Classic Park Unit 1

City Plan Commission — July 31, 2025 **REVISED**

CASE NUMBER/TYPE:	SUSU25-00062 – Resubdivision Preliminary
CASE MANAGER:	Myrna Aguilar, (915) 212-1584, AguilarMP@elpasotexas.gov
PROPERTY OWNER:	Direct Home Sales, Inc.
REPRESENTATIVE:	Conde, Inc.
LOCATION:	East of Mesquite Hill Dr. and North of Dyer St. (District 4)
PROPERTY AREA:	5.12 acres
VESTED RIGHTS STATUS:	Not Vested
PARK FEES:	\$34,250.00
EXCEPTIONS/MODIFICATIONS:	Yes, see following section
ZONING DISTRICT(S):	R-5 (Residential)
PUBLIC INPUT:	One inquiring email received as of 07/30/2025

PROPOSED CROSS-SECTION:

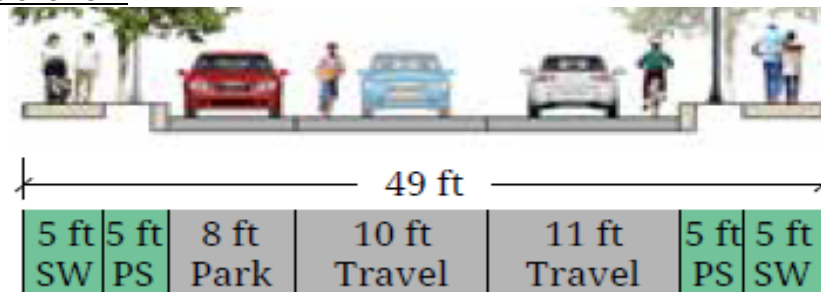
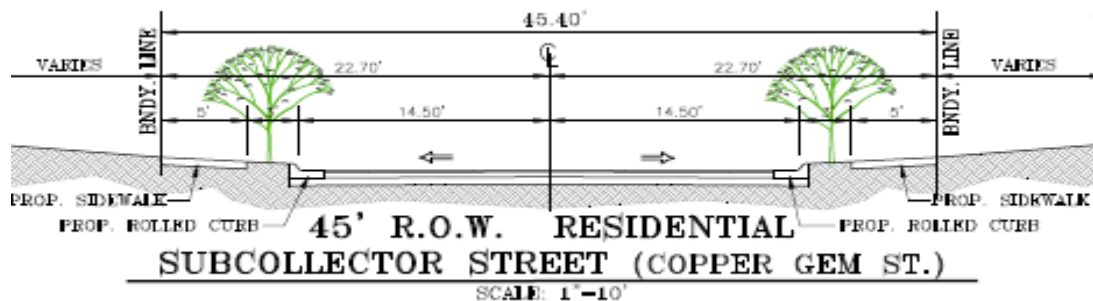
1. To allow the connectivity index to be 0.75 instead of the required 1.4 for the subdivision.
2. To waive the construction of two feet (2') of planter strip on each side of Copper Gem St. for a total of four feet (4').

EVALUATION OF EXCEPTION REQUEST: The exception request to waive right-of-way improvements meets the criteria set forth in El Paso City Code 19.48.030(A), which allows for exceptions under special circumstances arising from the physical surroundings, shape, topography, or other features affecting the land, such that the strict application of the code would create an unnecessary hardship or inequity for the applicant. In this case, the exception is requested due to a lot being resubdivided and converted into a local street, resulting in only one point of access to the proposed subdivision. Additionally, surrounding developments constrain the ability to construct a full planter strip without reducing the width of the roadway.

CLASSIC PARK UNIT 1
BEING A REPLAT OF LOT 69, BLOCK 28, MESQUITE
HILLS UNIT FOUR, AND ALL OF TRACTS 7
AND 7A, SECTION 16, BLOCK 80, TOWNSHIP 1,
TEXAS AND PACIFIC RAILROAD CO. SURVEYS,
CITY OF EL PASO, EL PASO COUNTY, TEXAS
CONTAINING: 5.1312 ACRES

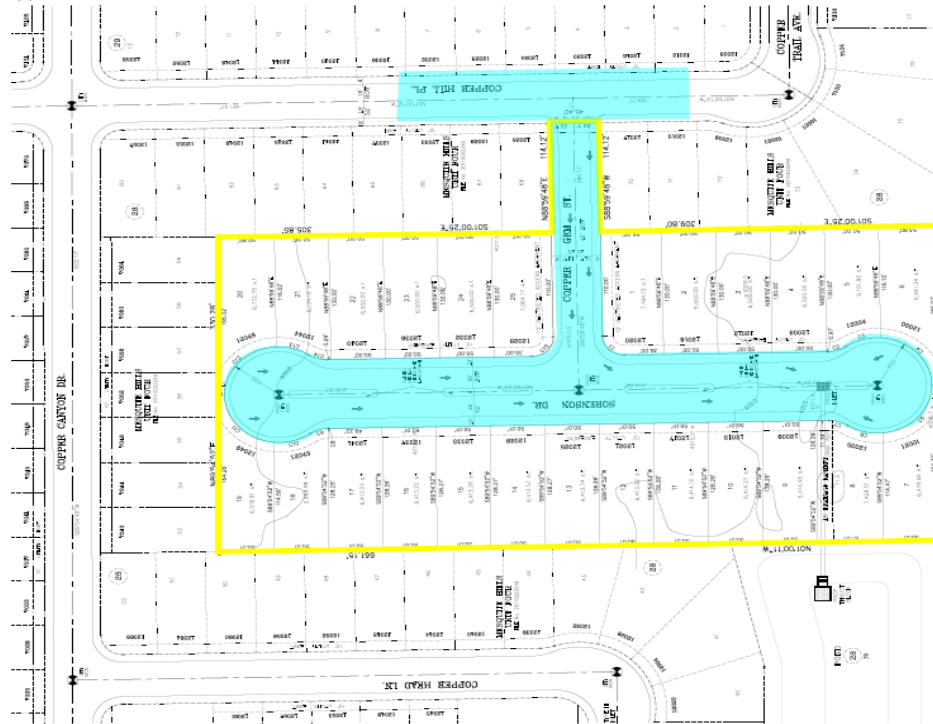
1. Provide drainage plan sheet from Mesquite Hills Unit 4, to verify existing stormwater City Pond (Lot 39, Block 28) capacity for additional runoff.
2. The existing ponding area for subdivision shall have enough capacity to hold the developed runoff for a designated 100-yr. storm event, provide drainage calculations.
3. Sidewalk shall be required along R.O.W. (Cooper Gem St.) at the time of grading permit.
4. Provide directional ramps at the street corners.
5. On typical Sorenson Street cross section, label landscaping along raised median.
6. Subdivision Improvement plans are required.
7. Review and approval from Environmental Services Department will be required for median openings at time of SIP plans.
8. Print-out of the mathematical closure is ok.

Need Block #.

Please change the Restricted Easement to 10' Wide Utility Easement, along Copper Gem St, for future access for electrical services.

Requesting No Parking designation on Copper Gem St.
